MARRICKVILLE COMMUNITY HUB PROJECT

DA201600434
DESIGN RESPONSE MAY 2017

RESPONSE TO COUNCIL LETTER 7 MARCH 2017

APT 30301 (TYPICAL FOR STACK)

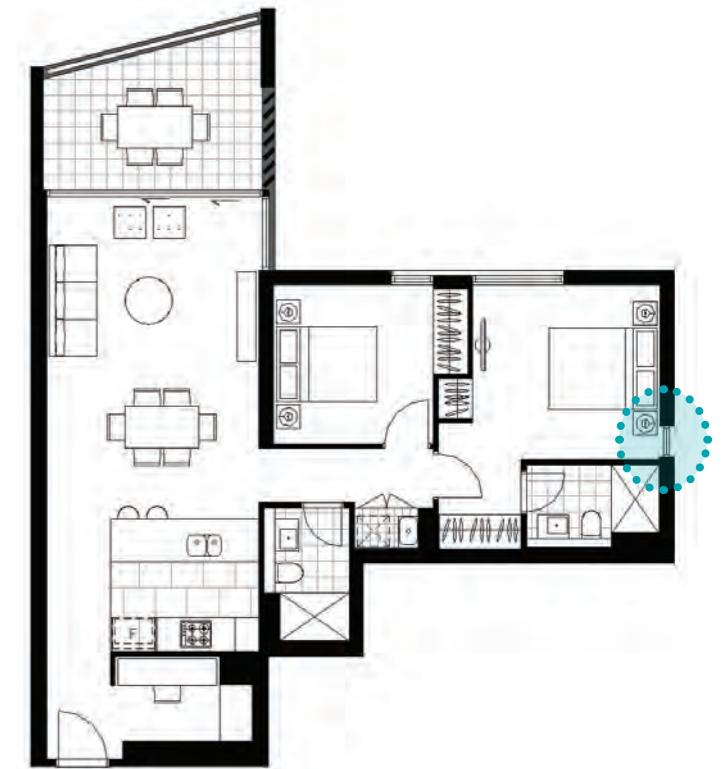
Windtech Consultants has undertaken an assessment of the project and provided a cross ventilation report. As a result of their assessment, a number of design modifications have been made to improve the performance of certain apartments and to take advantage of aspect to encourage improved cross ventilation. The improvements are shown opposite for reference.

ADDITIONAL OPERABLE WINDOW FACING NORTH-WEST (LIVING ROOM & BED 1 HAVE OPENINGS FACING NORTH)

APT 20402 PLAN (TYPICAL FOR STACK)
VENTILATION DUCT PROVIDED THROUGH KITCHEN BULKHEAD TO BREEZEWAY

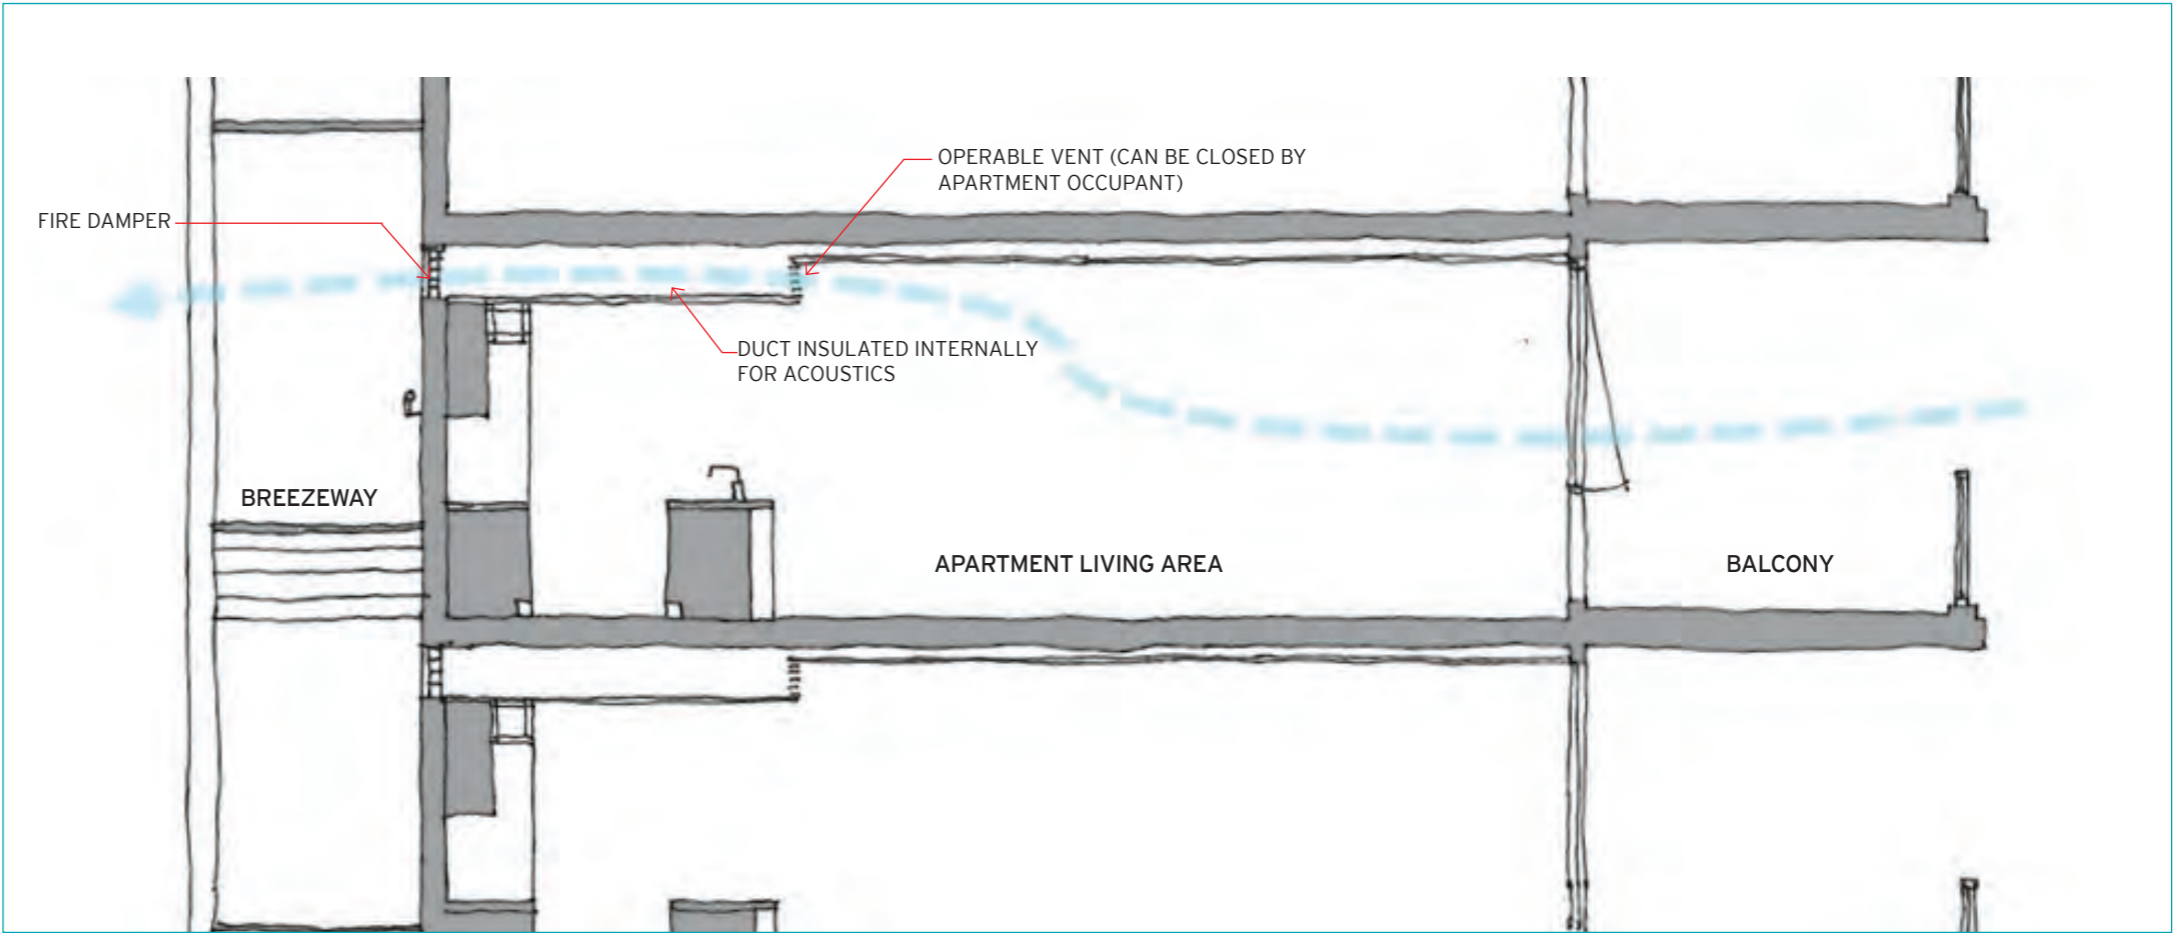
Of the apartments noted above, only 20002 and 20003 do not achieve cross ventilation. In place of these, we have modified a stack of six apartments in the centre of Building A by adding a vent with a cross-sectional area of 0.4 m² to the bulkhead of each apartment. This vent connects through to the break in the building from the west, allowing natural cross flow through from east-facing glazing in the apartment. Details of this solution are shown on the following page.

APT 20402 CROSS SECTION
DUCT PROVIDES VENTILATION THROUGH BULKHEAD TO PROVIDE OUTLET ON THE LEEWARD SIDE, TO THE WEST FACADE, TO BALANCE WINDWARD GLAZING FACING EAST

APT 10205 - BALCONY 9 SQM (-1 SQM) (1 OF 10)

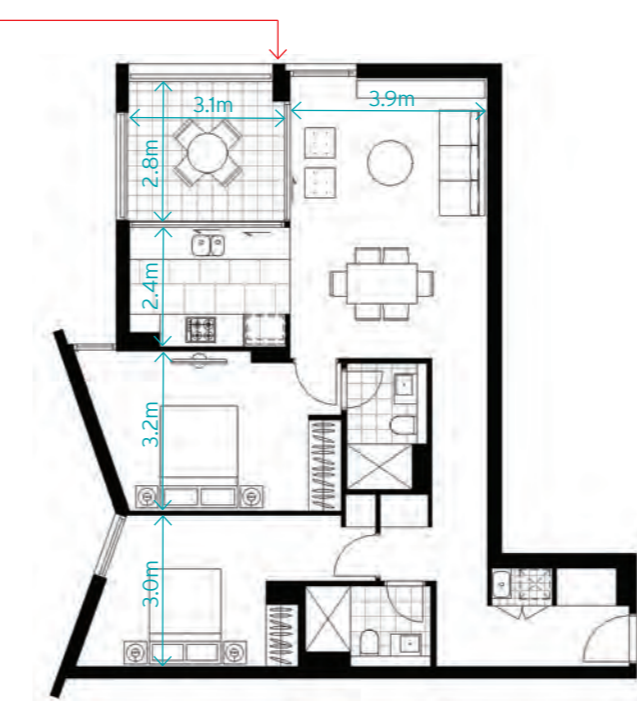
However, the objective of 4E-1, i.e. that ‘apartments provide appropriately sized private open space and balconies to enhance residential amenity,’ is achieved for these 10 apartments. Generally the balcony area is only 1m² or 2m² less than the ADG guide, and in each case, we can demonstrate that the balconies are useable and furnishable, that they will easily accommodate a table with 2-4 chairs and open from the primary living space as per the ADG recommendation, and therefore provide the necessary amenity.

BALCONY WIDTH IS DETERMINED BY RELATIONSHIP TO FACADE ELEMENTS, AND CANNOT BE INCREASED WITHOUT COMPROMISING LIVING ROOM WIDTH. TO ACHIEVE 10SQM, AN EXTRA 0.4M DEPTH WOULD NEED TO BE ADDED TO THE BALCONY, AND THIS IS NOT POSSIBLE OR APPROPRIATE WITH MINIMUM BEDROOM AND KITCHEN DIMENSIONS. BALCONY ACCOMMODATES 4 SEAT TABLE AS PER ADG.

UNIT SIZE - EXAMPLE EXTRACT APARTMENT 10202
1:100 PLAN DIMENSIONED & FURNISHED AND WITH STORAGE IDENTIFIED

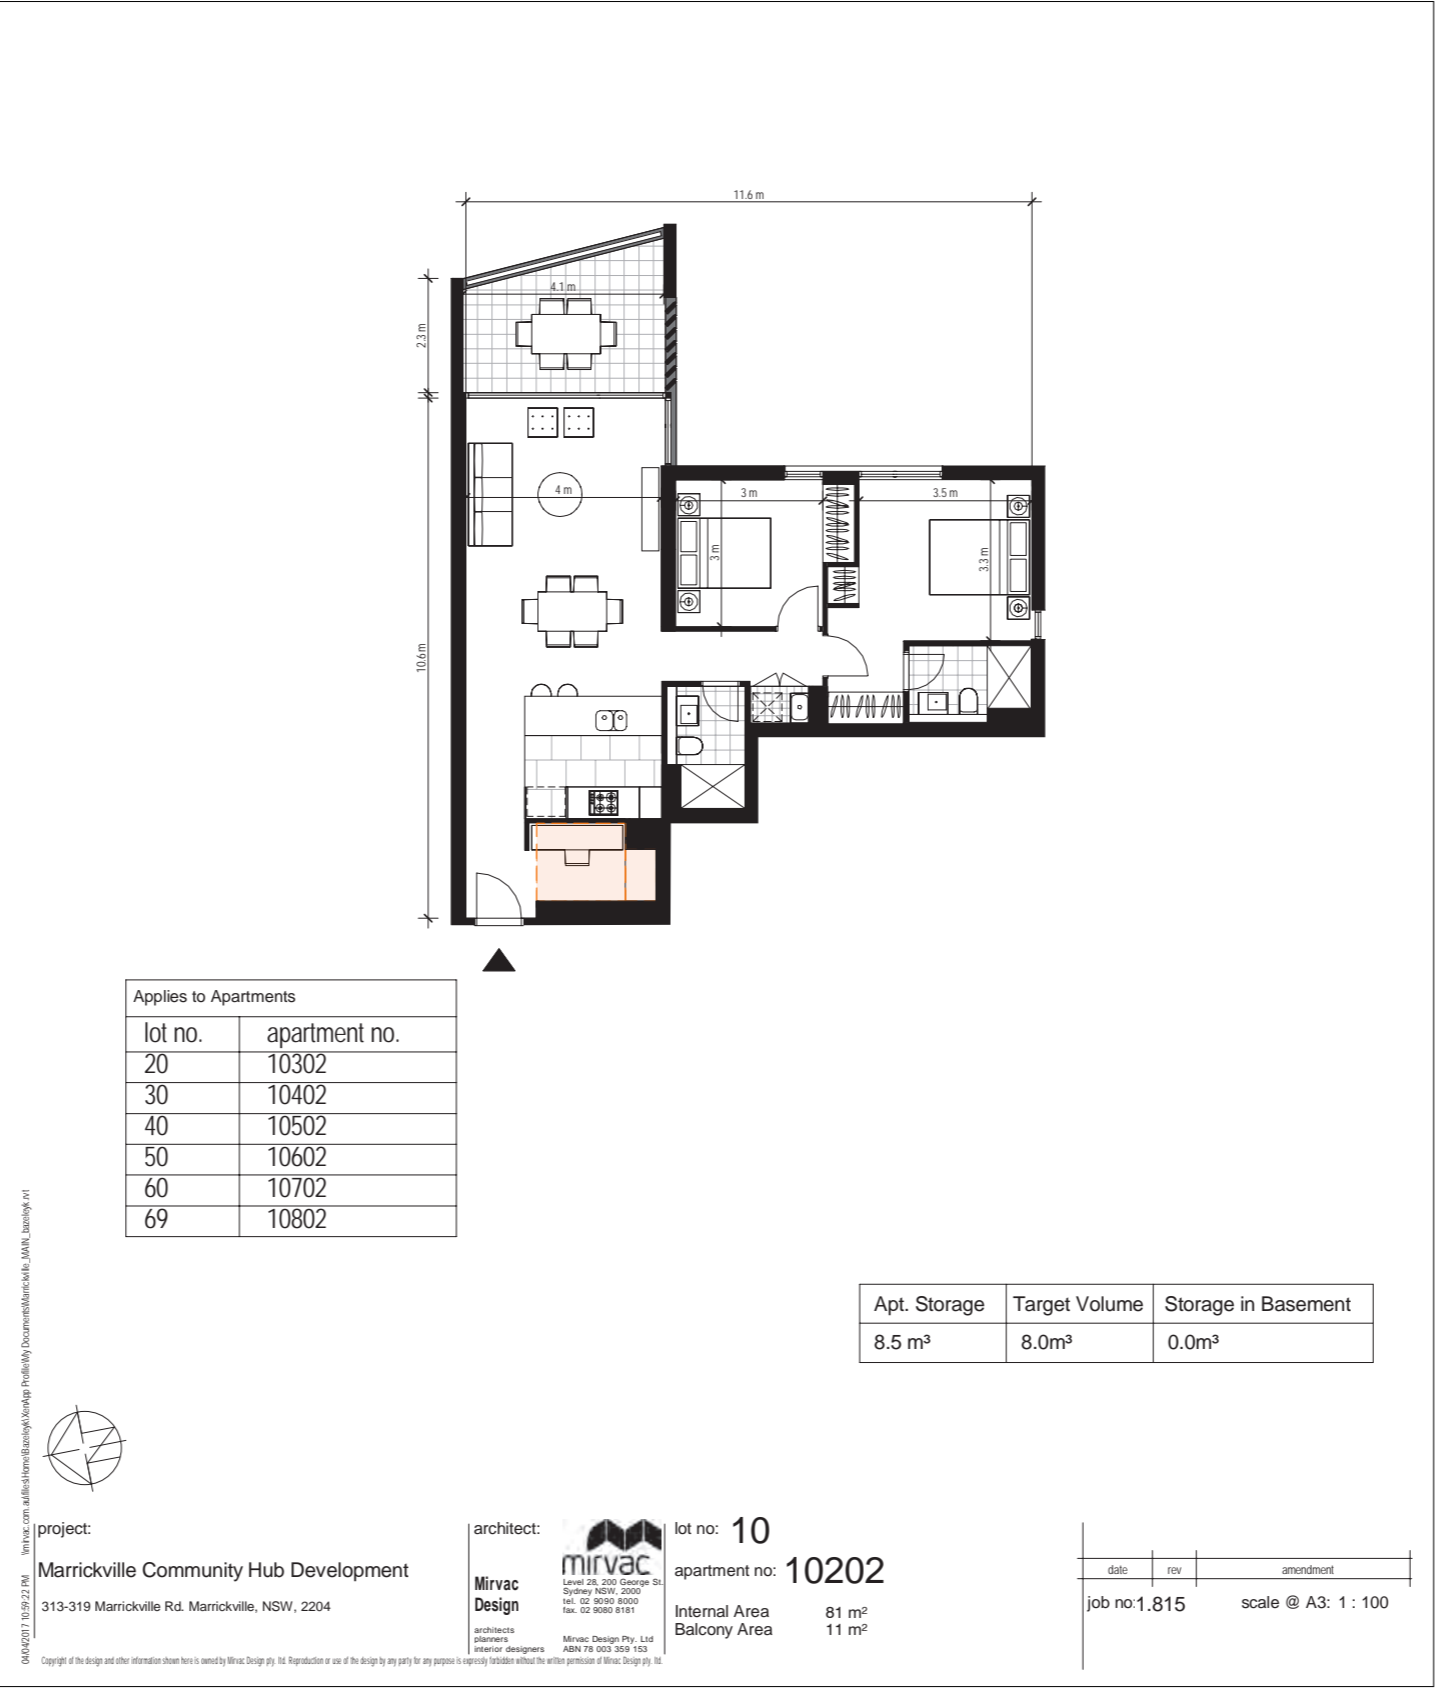
As previously requested, the floor plans are to include dimensions and should be at a scale that can be used to check the application.

The plans should be updated so that the actual storage volume is identified (notated) for each storage area identified on the plans.

In addition to the storage schedule provided in our response of 13 January 2017, we have now shown the location of all counted storage within apartments on the 1:100 individual apartment plans, and we have noted the amount of storage which will be allocated to the apartment in the basement.

Dimensioned 1:100 plans have been provided for each unit, with furniture shown in each case to demonstrate liveability. In keeping with objective 4D-1 of the ADG, the layout of rooms within each apartment is functional, well-organised and provides a high standard of amenity.

BUILDING A NORTH BOUNDARY PLAN AT GROUND LEVEL
ARTICULATION ZONE SHOWING EFFECTIVE SETBACK OF GLAZING

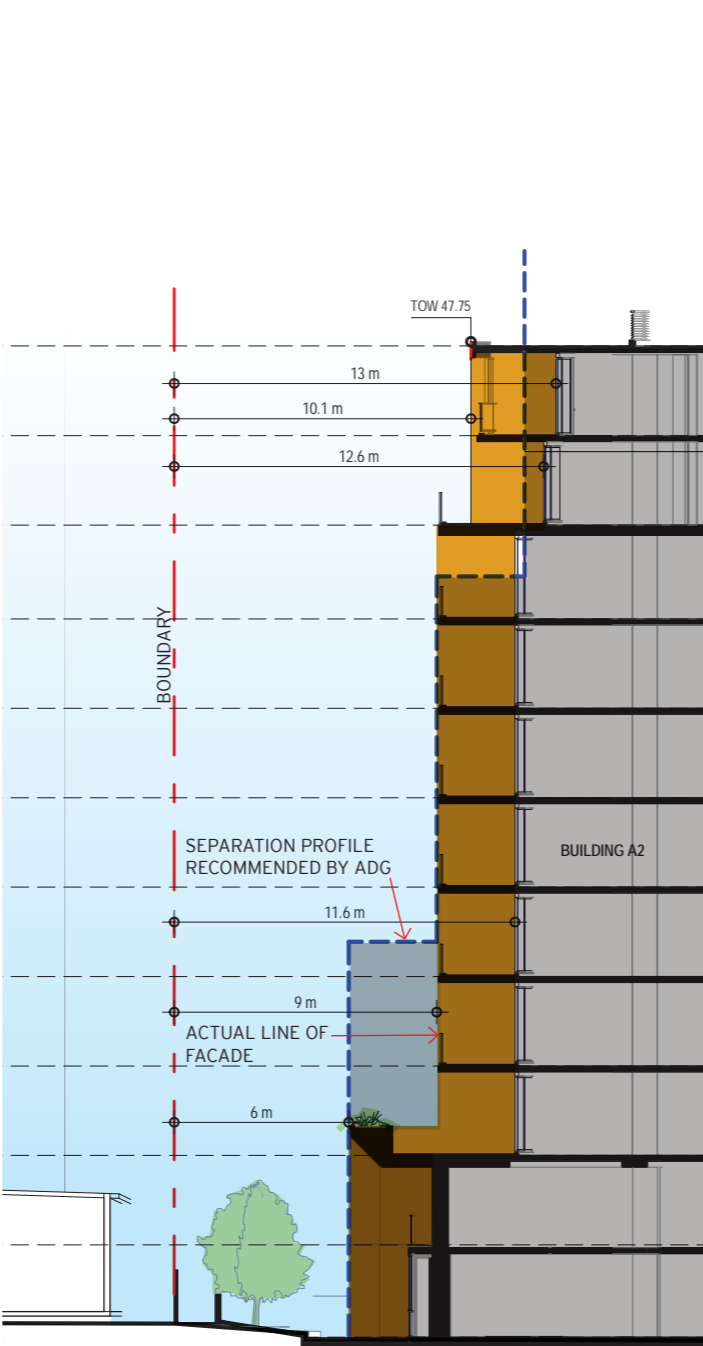
It is also noted that the Masterplan controls for the site envisage a distinct change in scale along this boundary, however it is considered that the ADG building separation distances mentioned above should be complied with at a minimum along this important transition zone. Separation above the minimum should also be considered. In this respect the additional 3m setback should be considered.

BUILDING A NORTH BOUNDARY PLAN AT TYPICAL LEVEL (L04)
ARTICULATION ZONE SHOWING EFFECTIVE SETBACK OF GLAZING & DEEP BALCONIES, WHICH PROVIDES GREATER AMENITY FOR BOTH PROPOSED RESIDENTS AND EXISTING NEIGHBOURS

PROPOSED BUILDING A SECTION WITH ADG OVERLAY
CURRENT MASSING SHOWS RESPONSE TO CONTEXT + ARTICULATION

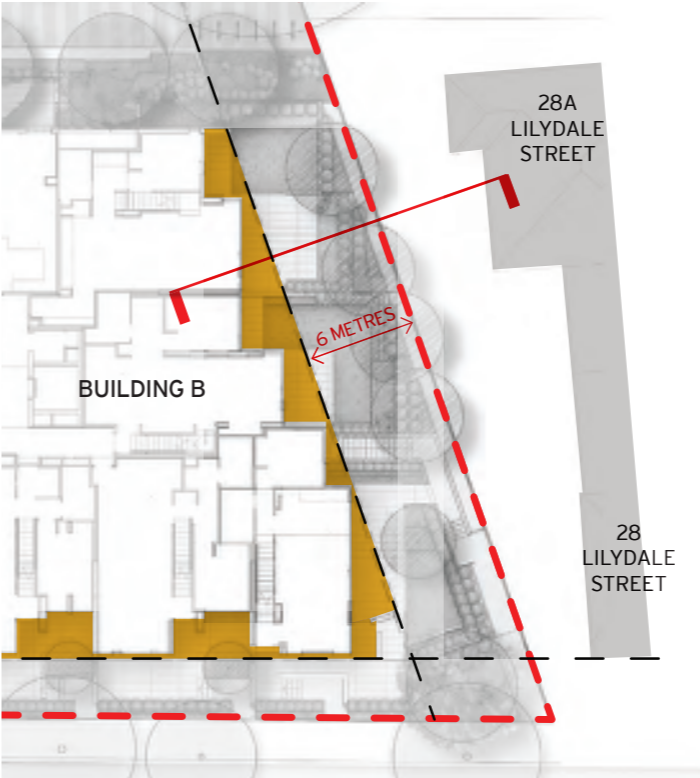
Additionally, under Part 2F Building Separation the ADG outlines that at the boundary, between a change in zone from apartment buildings to a lower density area, the recommended building setback distances from the boundary should be increased by 3m.

The Design Guidance section of Objective 3F1 recommends that apartment buildings should provide an additional 3m separation distance, on top of the distances established by the Design Criteria, for development adjacent to a different zone that permits lower density residential development. It is noted that the sites to the north of Building A2 and Building B currently contain detached residential dwellings which is a lower density residential use than the residential flat building proposed at the site. However, the objective does not require consideration of the existing built form, rather, it requires consideration be given to the type of land uses permitted within the adjacent zones.

The diagram explaining the recommendation for an additional 3 metres building separation where there is a change of scale is contained in Section 3-F of the ADG, i.e. relating to visual privacy. This, in combination with the note, 'to resolve amenity conflicts', suggests that the chief purpose of the additional 3 metres is to assist with improving amenity - i.e. privacy and solar access. Neither of these are improved with increasing the distance of the northern boundary setback in the case of this project, as acknowledged by the Council in our meeting. Significant boundary landscaping, as well as an easement for stormwater on the northern side of the boundary, ensure a deep soil landscape buffer, complete with existing 14m and 18m high trees which are to be retained.
